Agenda Memorandum

Planning Commission Meeting  
February 13, 2024

**SUBJECT:** Public Hearing and Consideration of an Official Development Plan for Uplands Filing 1, Block 4 / PA-A(4)

## OUTSTANDING CORRECTIONS TO ODP

Sheet 8:

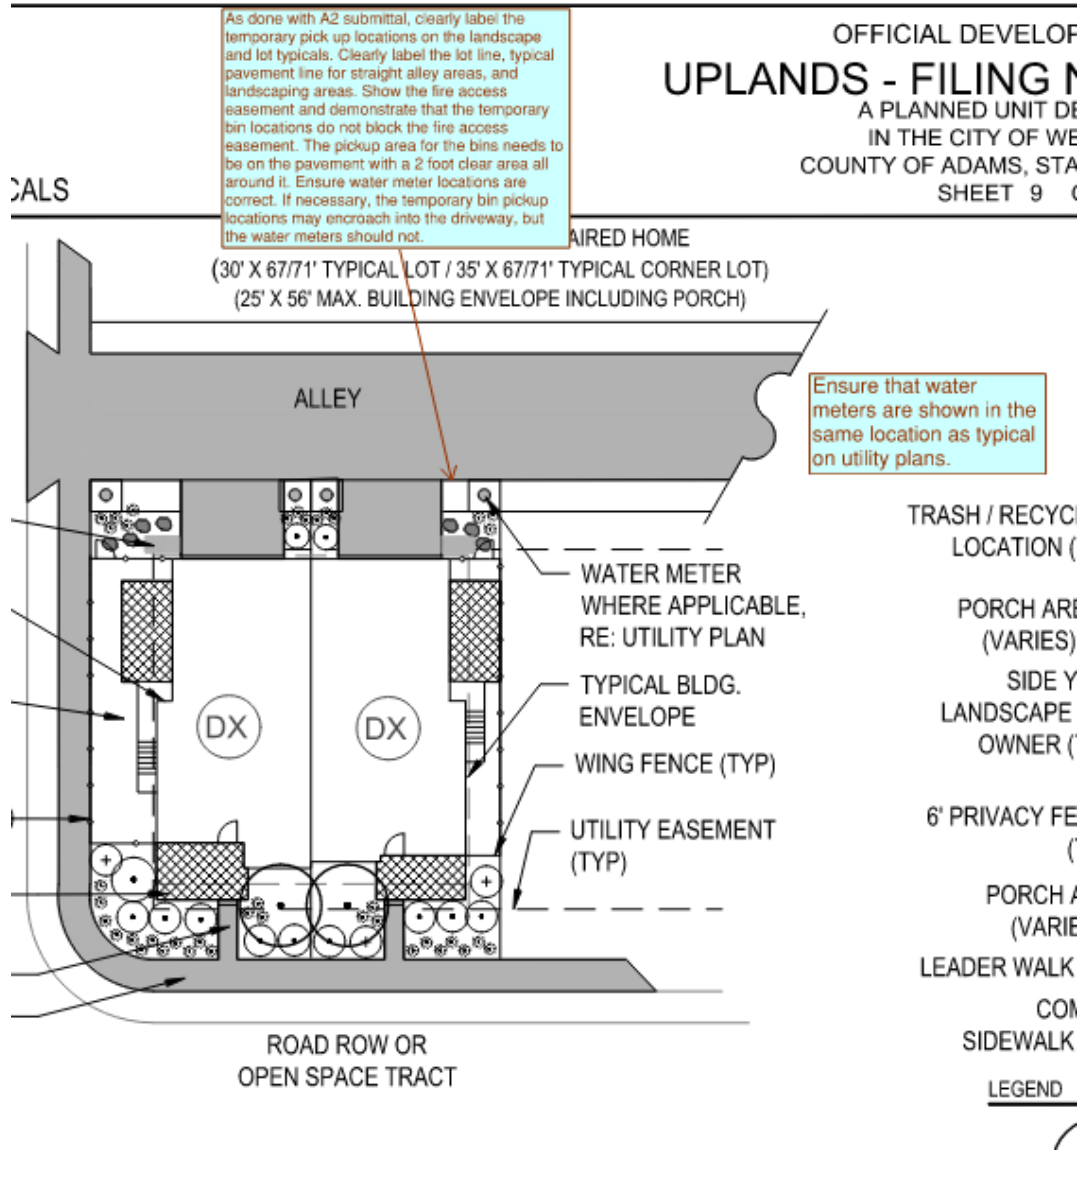
Formatting:  
As with the A2 submittal, please change the title of this table to "LOT STANDARDS".

The quantities do not match the table on the exceptions page. Please use that same format, and update with the revisions to that table.

[Switch - list SFD first]

Sheet 10:

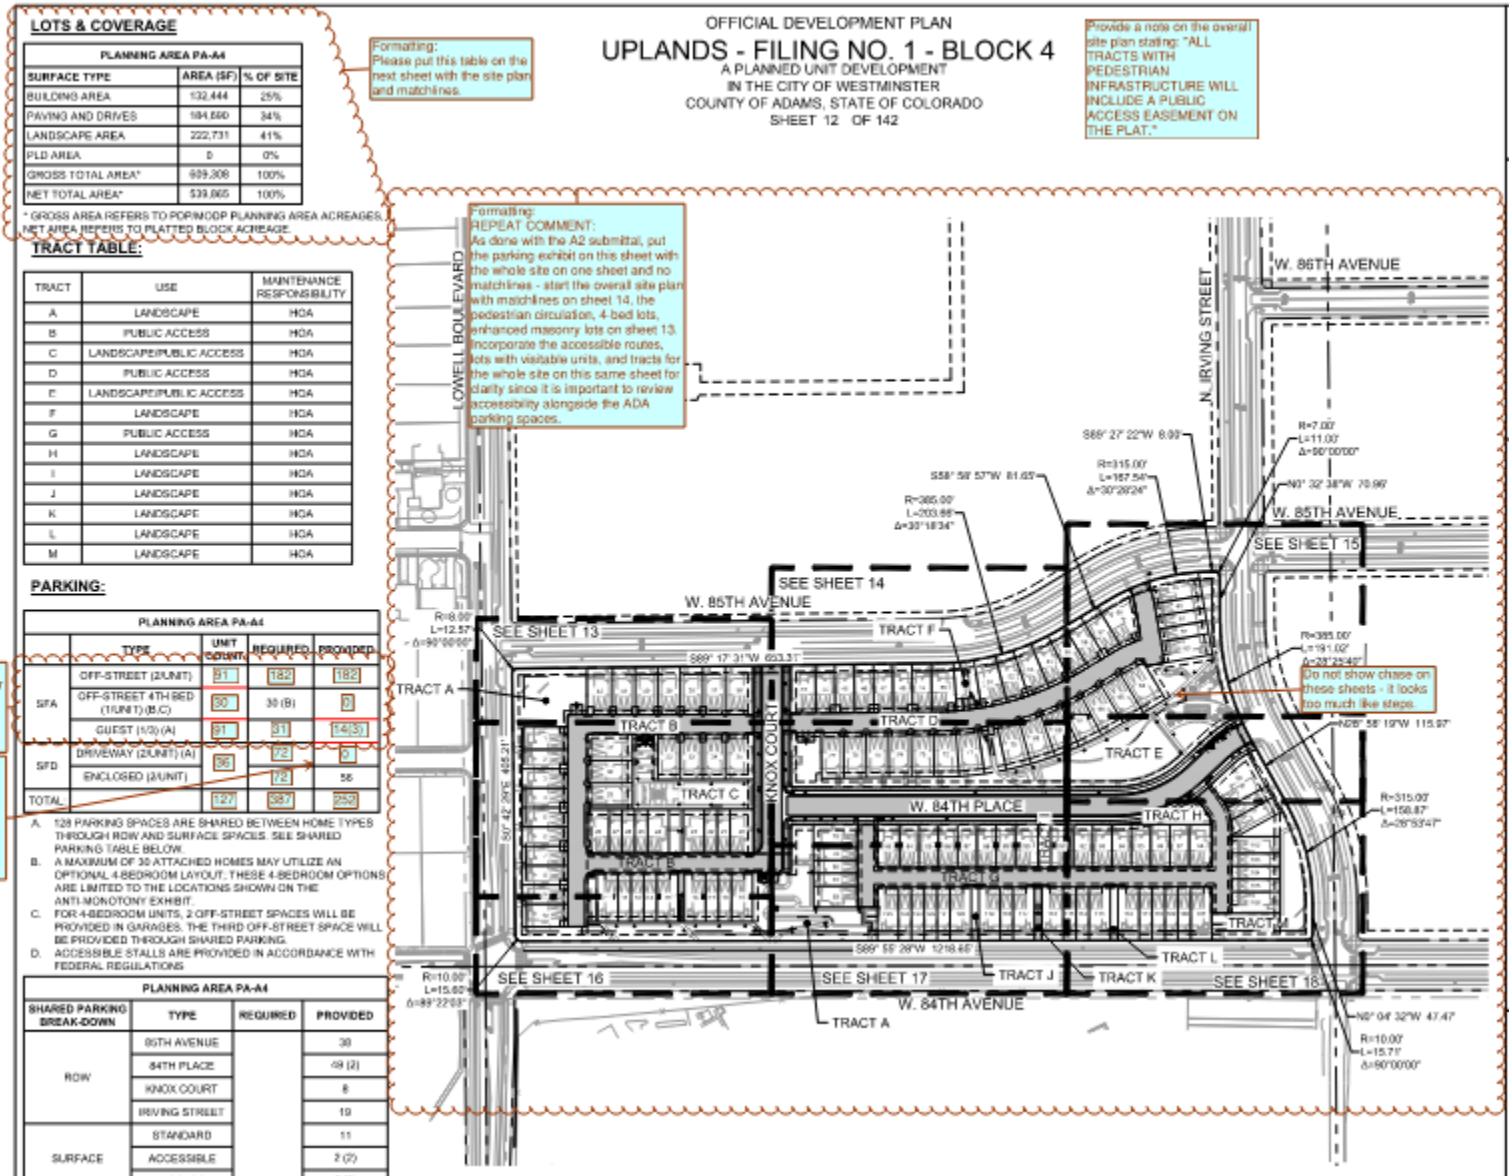
Please address all comments from previous sheet on this sheet too.

Sheet 13:

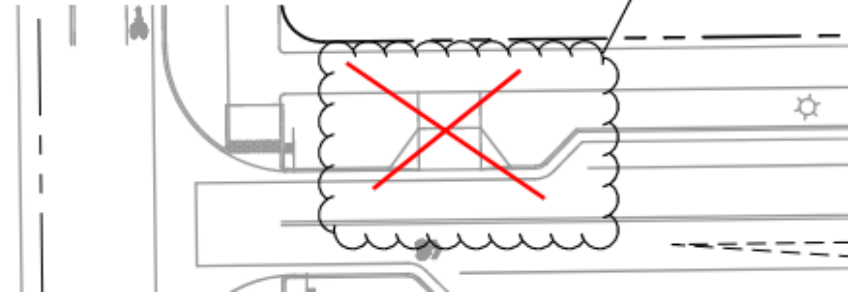
Formatting:  
As done with A2 submittal, please only show enhanced masonry on the pedestrian circulation exhibit, not on the individual larger scale site plans since this does not read well here.

No drive access supported at this location

Sheet 22:

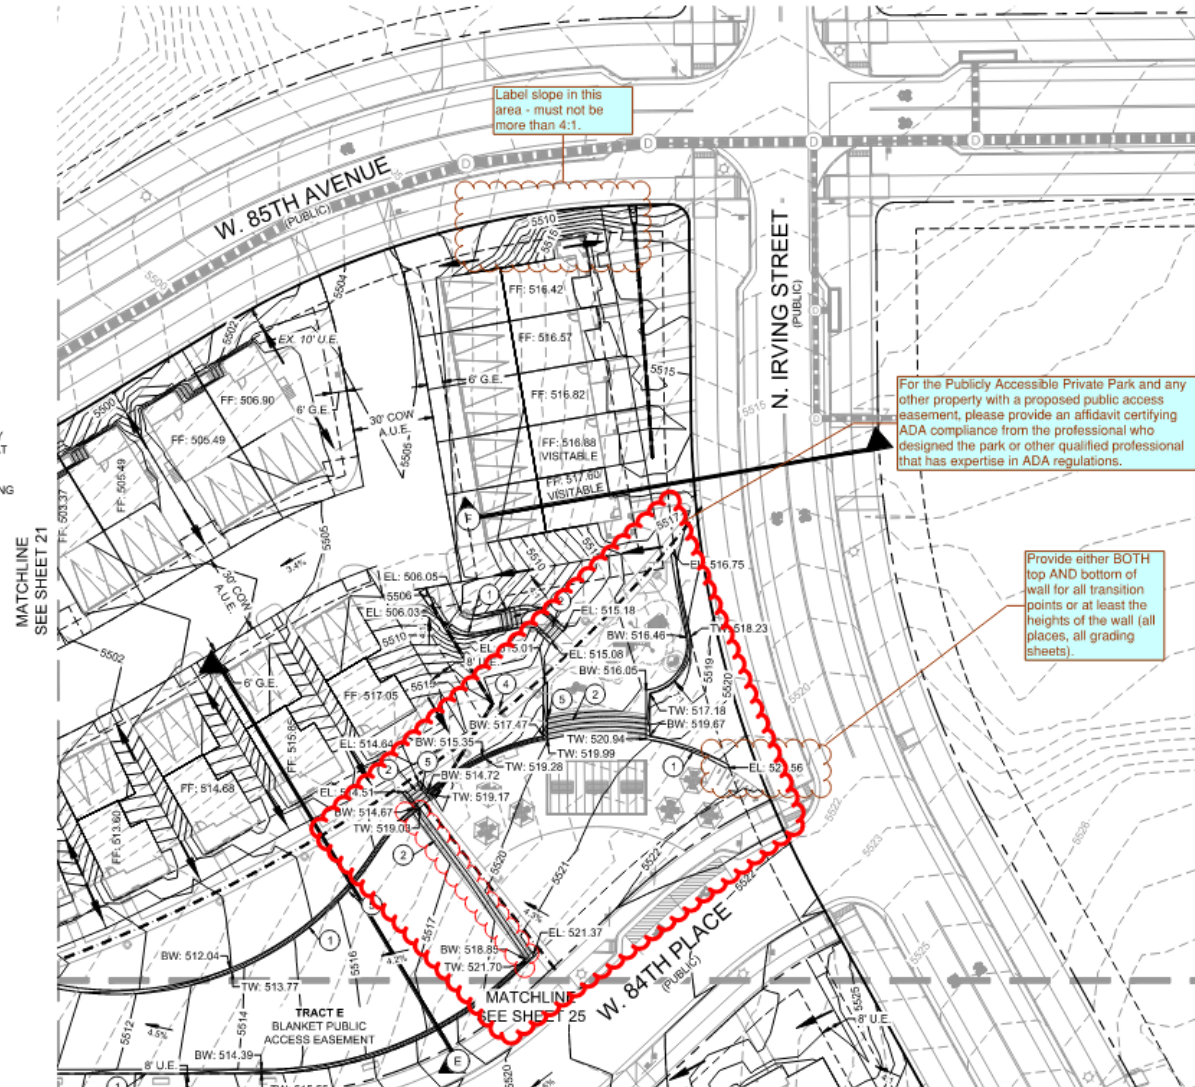
Formatting:  
As with A2 submittal, please use a different line symbol for the wall railing. I would suggest making the wall lines thick but much lighter as this symbol is now and then using the same dark line with the same line type as on the site plan for the railing (all grading sheets).

Sheet 28:

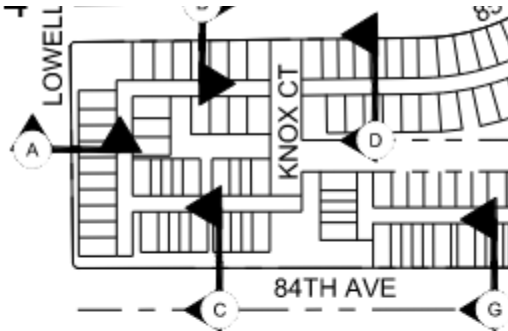
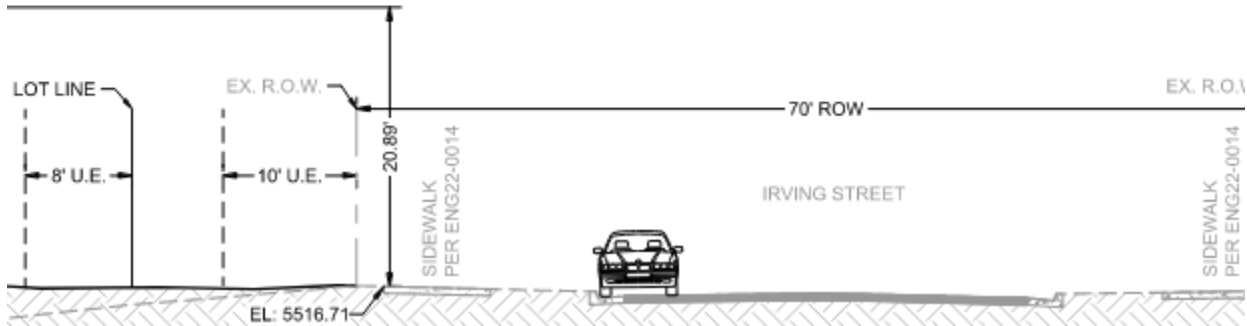
See and address all section comments on previous sheets.

Sheet 43:

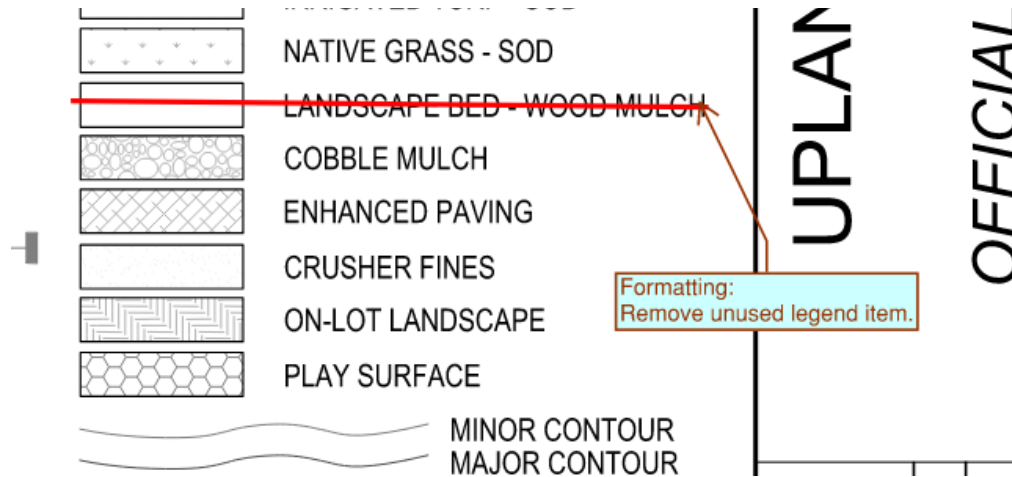
Change to "BLUEGRASS  
SOD MIX".

Sheet 47:

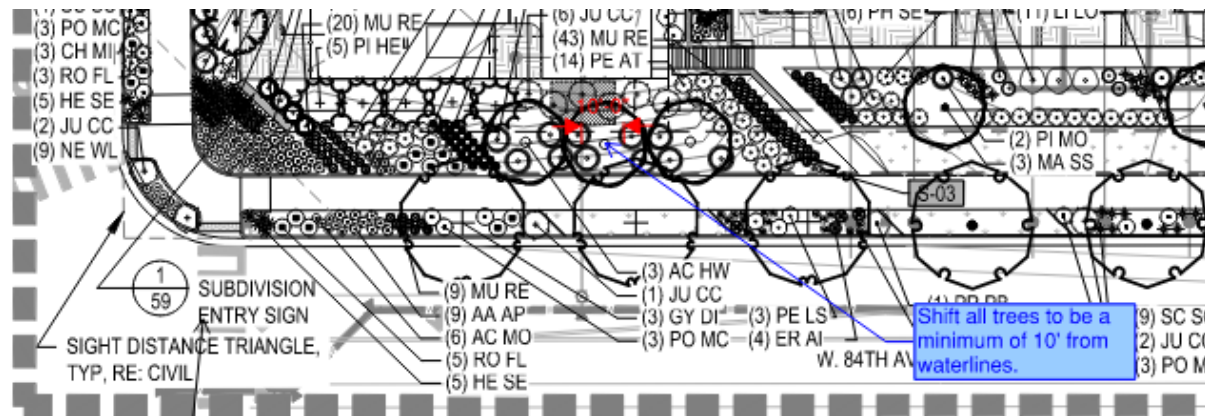
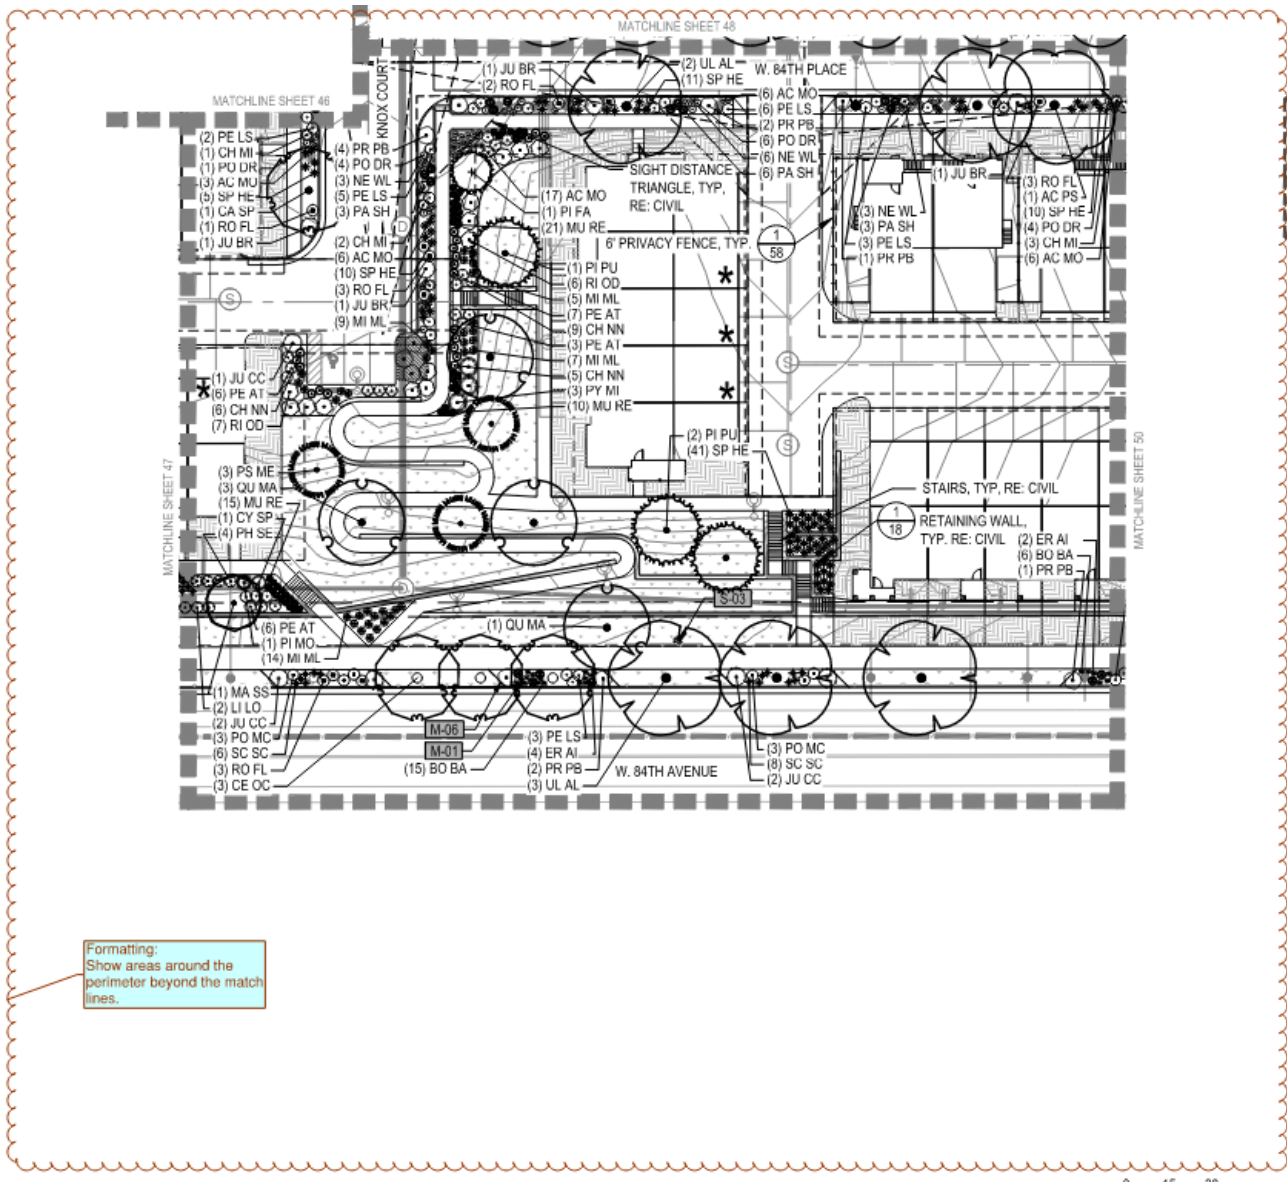
Subdivision entry signs must be located at the vehicular entrance to the subdivision. Relocate to 85th or Irving corners.

Sheet 59:

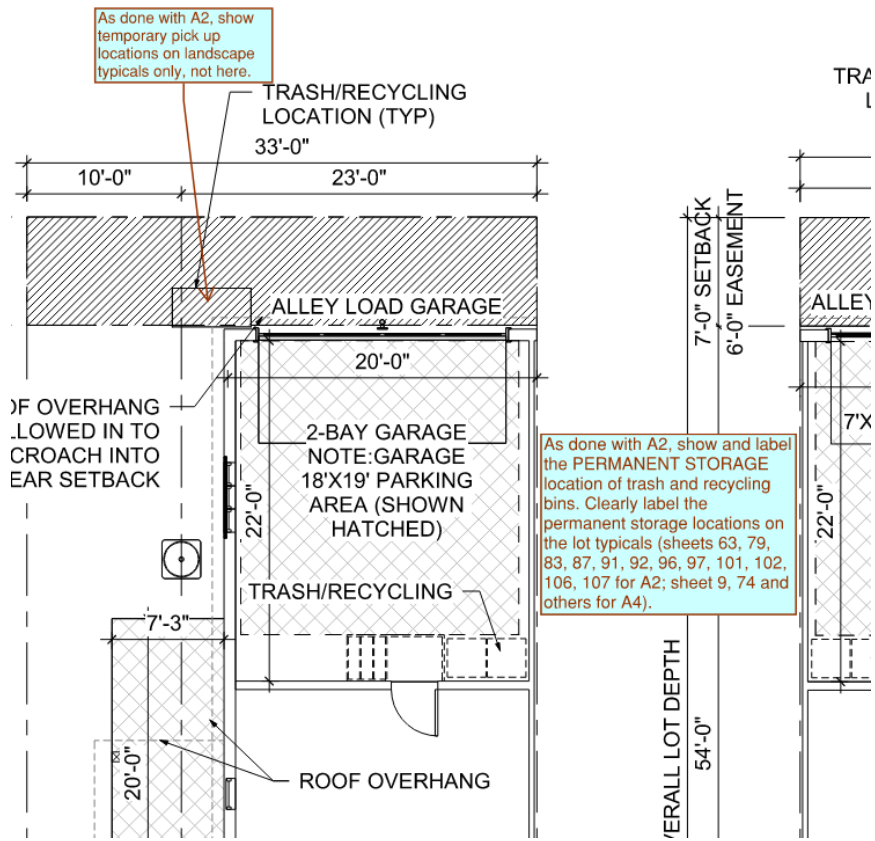
Repeat comment: Provide a detail where the landscaping abuts the alleys - detail cannot be located.

Sheet 135:

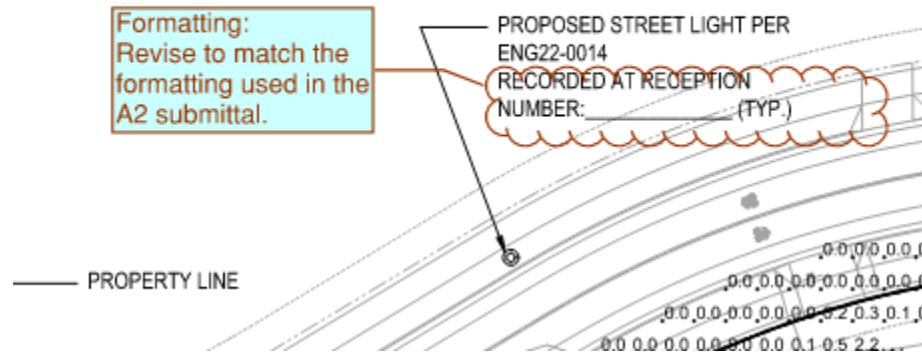
Include legend on all sheets.  
~~FOR SYMBOLS, LEGEND, ABBREVIATIONS, AND  
GENERAL DESCRIPTIONS, SEE LUMINAIRE SCHEDULE  
ON LIGHTING DETAILS SHEET (SHEET 137)~~

Formatting:  
Revise to match the  
formatting used in the  
A2 submittal.

Sheet 138:

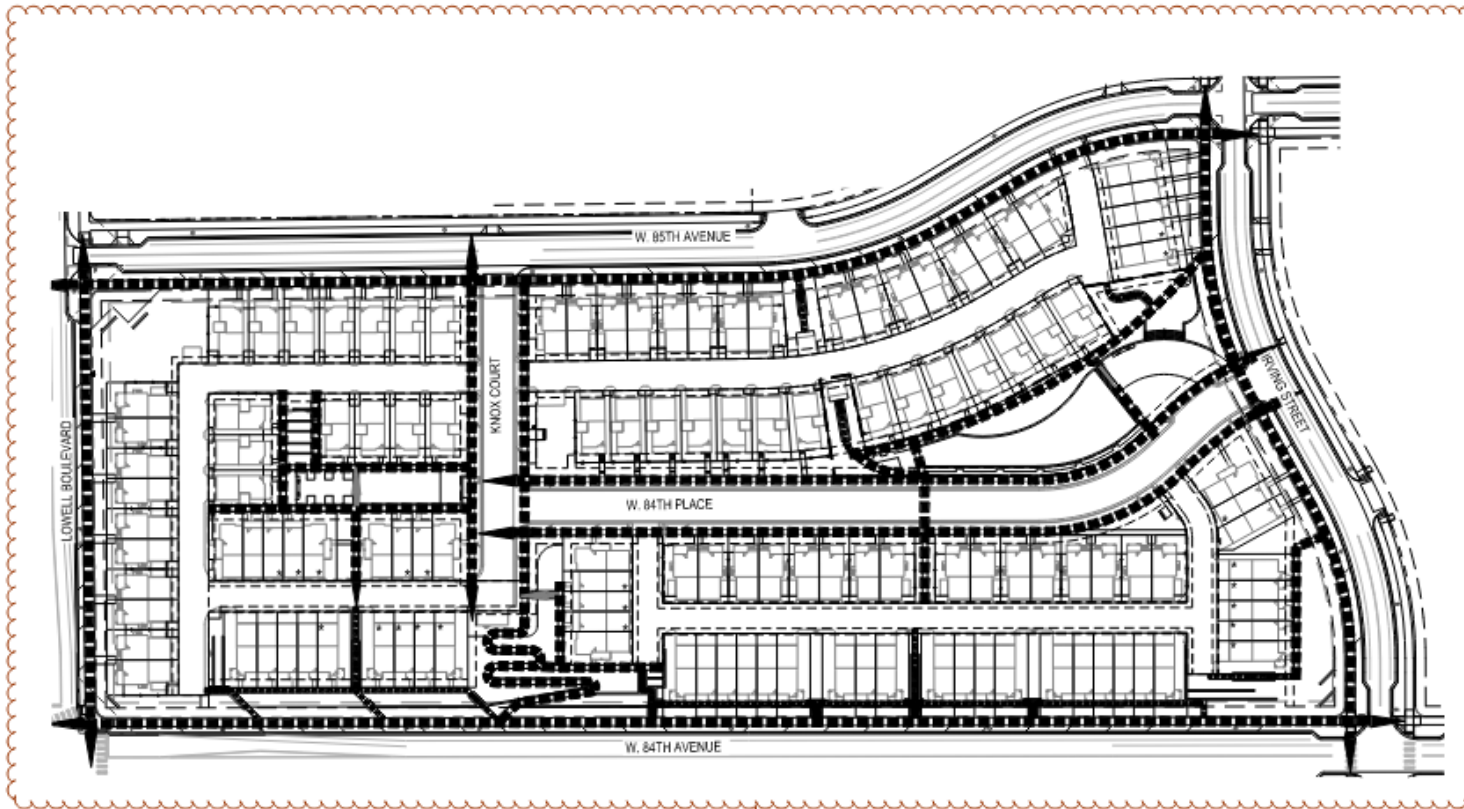
Formatting:  
 Revise exhibit to match the A2 submittal.

Formatting:  
 Make this sheet 12, the parking exhibit sheet 13, and then start the site plan on sheet 14.
